**RE: Assisted Living Home
Grading and Drainage Plan
Engineer's Stamp Date 7-12-16 (C19D062)**

Re: C19D062 - 7500 Oakland Ave. Grading Plan for Building Permit

ASSISTED LIVING HOME
LOT 13, BLOCK 3, UNIT 2, TRACT 2, NAA
GRADING & DRAINAGE PLAN

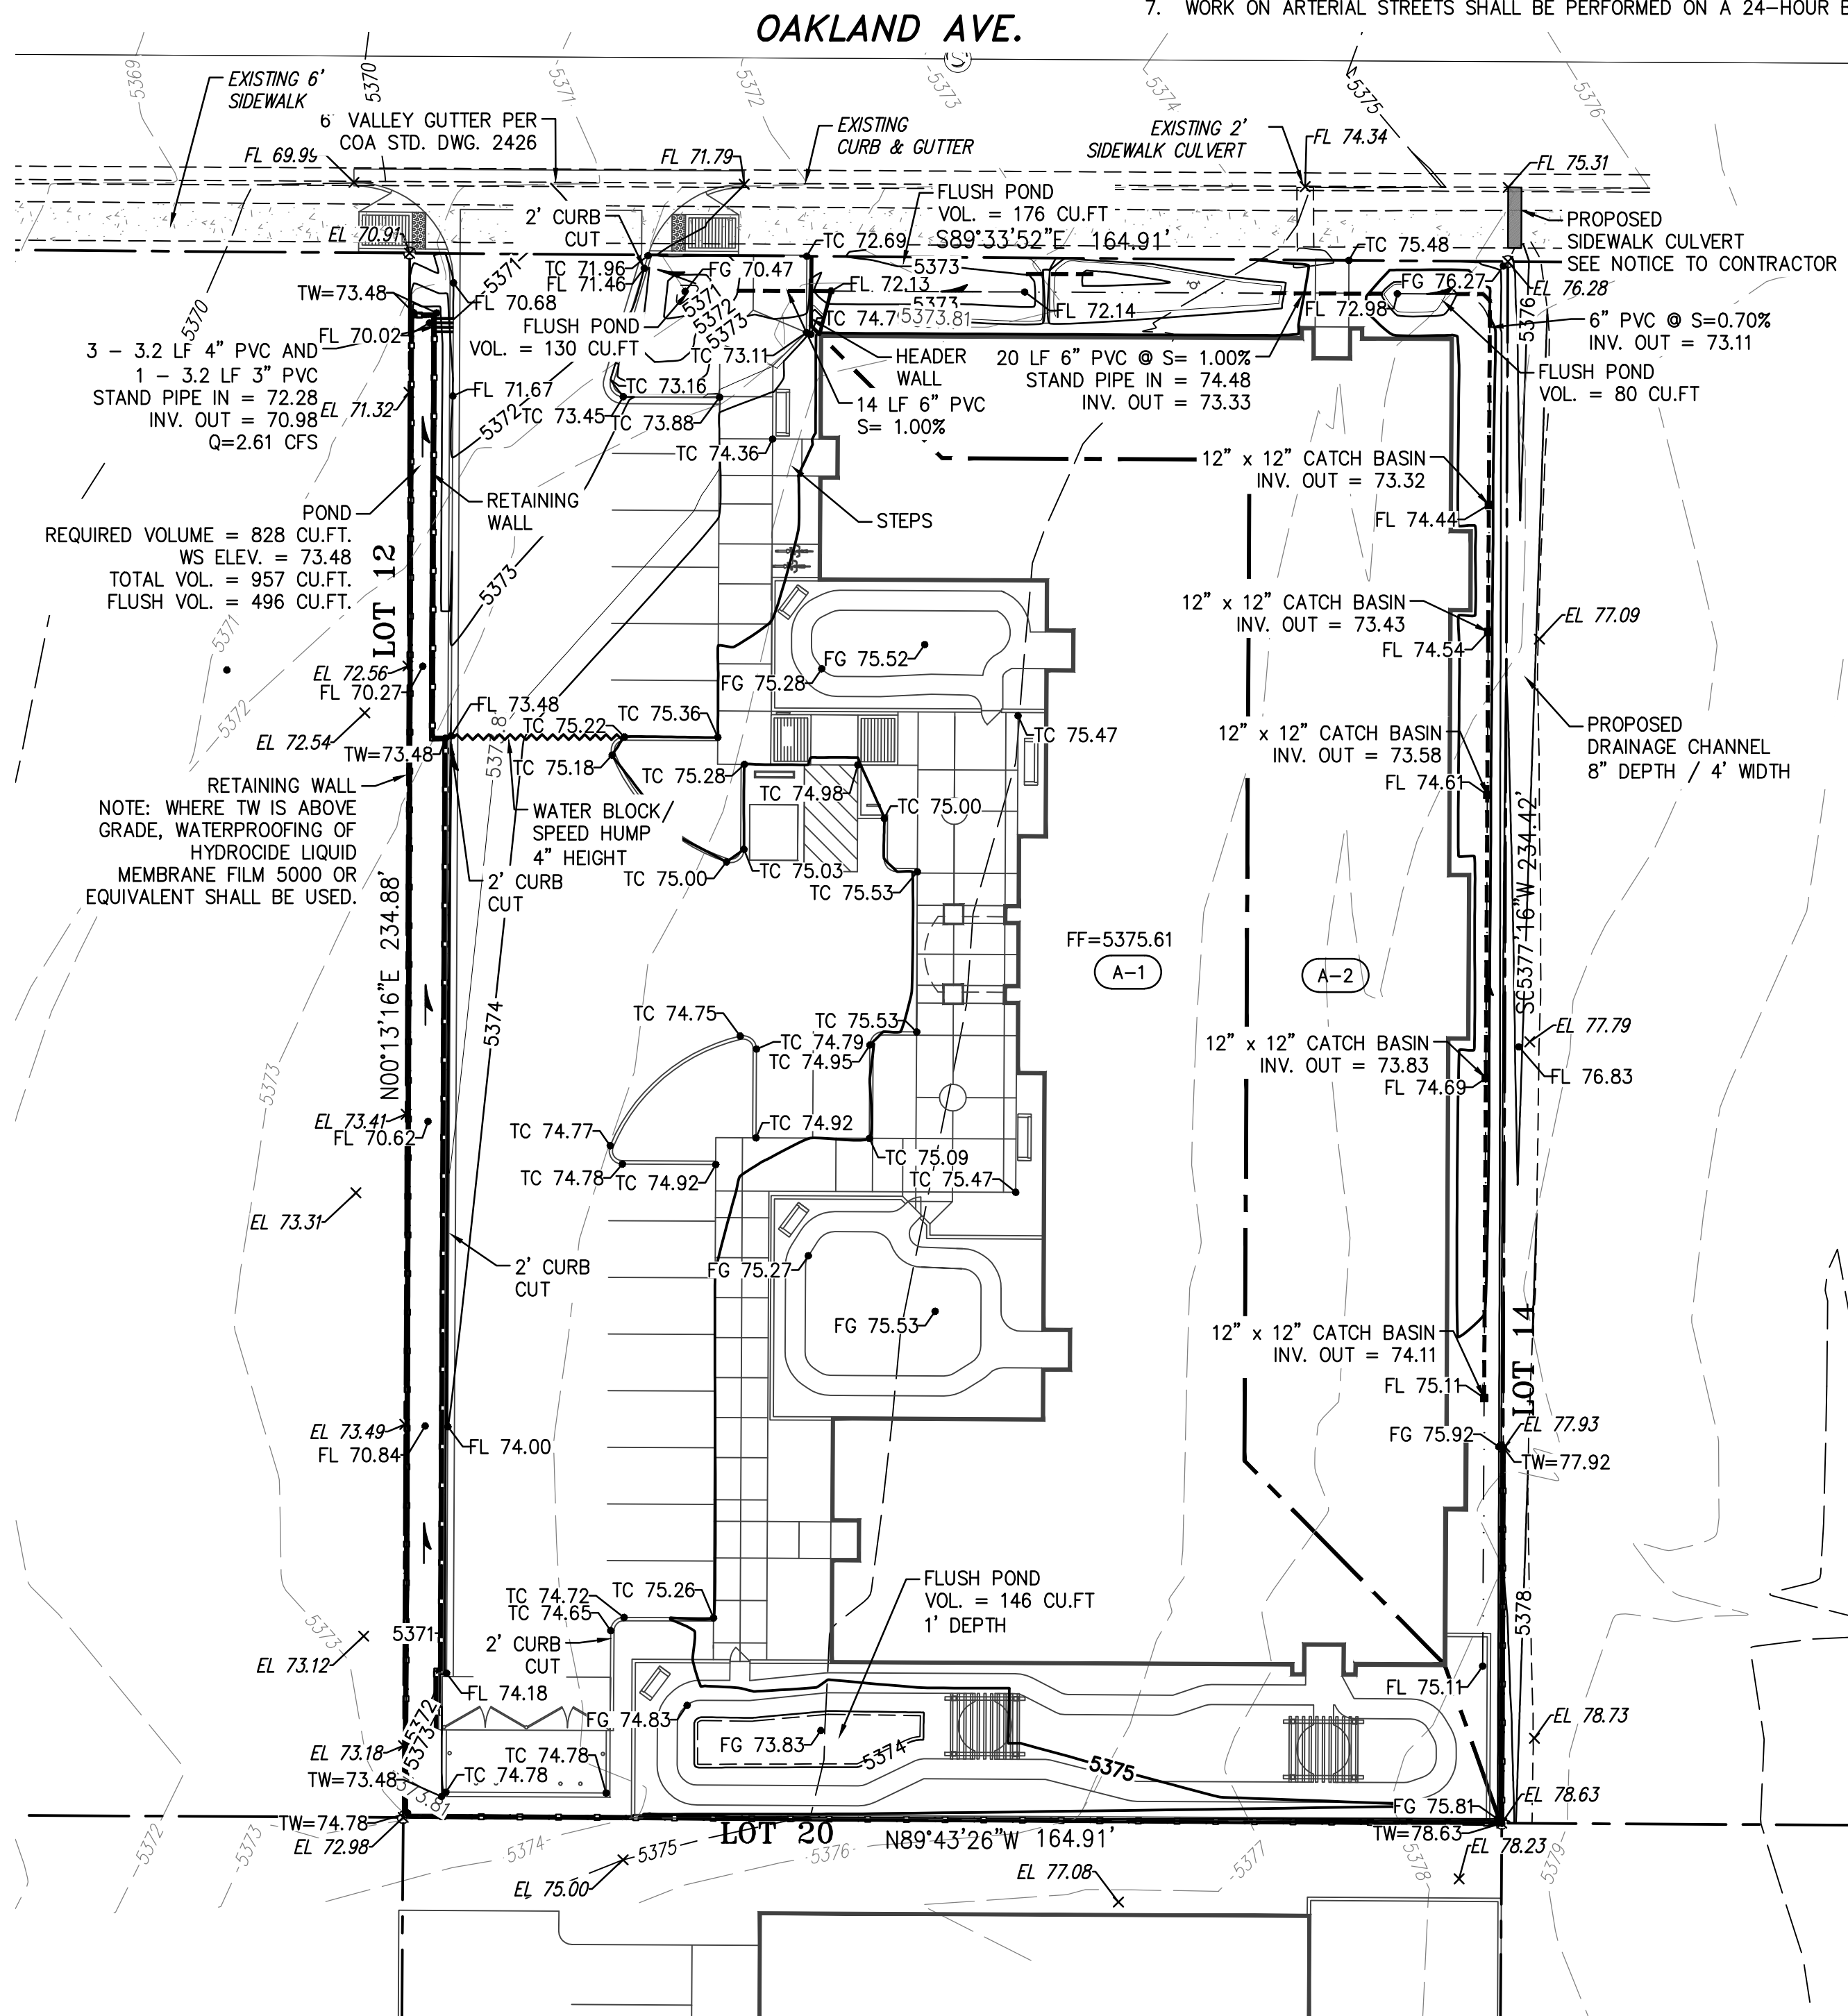
The revised Grading Plan for the above site is attached. We are requesting a review of the attached plan in support of the Building Permit of Assisted Living Home. The site is "Tract 2 Block 3, Unit 3 of North Albuquerque Acres" and is located at 7500 Oakland Ave. The review comments have been addressed with the following:

1. The application includes SO-19 request and appropriate notes.
2. TW grades are indicated for the terminus of each wall, and the BW grade is indicated by FG or FL depending on location.
3. The WSE, required volume and the provided volume are indicated on the plan. In addition, additional capacity is shown in the detention volume to accommodate landscaping.
4. The AHYMO calculations are attached to this submittal.
5. A 6" pipe has been added to route flow around sign.
6. The plan has been modified to 6" pipe for sidewalk crossings.
